Access Compliance Report

Public Rights-of-Way

(Curb Ramps)

Intersection ID: 10039822	Main Street: TOM_SHORT_RD	Cross Street: N/A	Location: SE
ADA ID: E201E423FDEE	Ramp Type: Perp	Initial Pass/Fail: Fail	Overall Compliance: No
Severity Score: 12.5			
Codes/Mitigation Info/Possible Solution		Field Measurements/Component Compliance

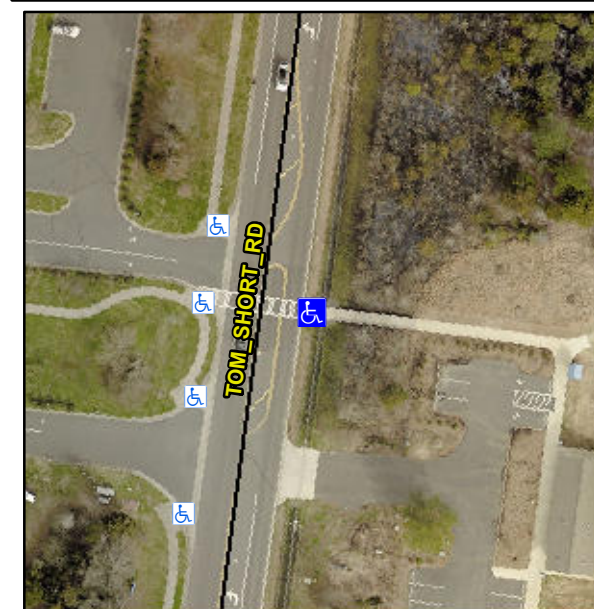
Not Found, R304.2.2

Compliance	Description	Data	Compliance	Description	Data
N/A	Ramp Length (in)	63.0	No	Ramp Slope (%)	8.8
Yes	Ramp Width (in)	71.0	Yes	Ramp XSlope (%)	0.5
N/A	Flare Type LT	N/A	N/A	Flare Type RT	N/A
N/A	Flare Slope LT (%)	N/A	N/A	Flare Slope RT (%)	N/A
N/A	Flare Traversable LT?	N/A	N/A	Flare Traversable RT?	N/A
N/A	Landing Length (in)	N/A	N/A	DWS Provided?	N/A
N/A	Landing Width (in)	N/A	N/A	DWS Contrast?	N/A
N/A	Landing Slope (%)	N/A	N/A	DWS Length (in)	N/A
N/A	Landing X Slope (%)	N/A	N/A	DWS Full Width?	N/A
N/A	Landing Curb? (Y/N)	N/A	N/A	DWS Offset (in)	N/A
N/A	Shared Landing?	N/A			
N/A	Gutter Ponding?	N/A	N/A	Gutter Slope (%)	N/A
N/A	Gutter Lip Ht (in)	N/A	N/A	Gutter X Slope (%)	N/A
N/A	Painted X Walk1?	Yes	N/A	Painted X Walk2?	N/A
	X Walk 1 Direction	To NW		X Walk 2 Direction	N/A
N/A	X Walk 1 Width (in)	88.0	N/A	X Walk 2 Width (in)	N/A
	X Walk 1 Slope (%)	1.7		X Walk 2 Slope (%)	N/A
	X Walk 1 X Slope (%)	0.0		X Walk 2 X Slope (%)	N/A

Remove & Replace Entire Ramp.
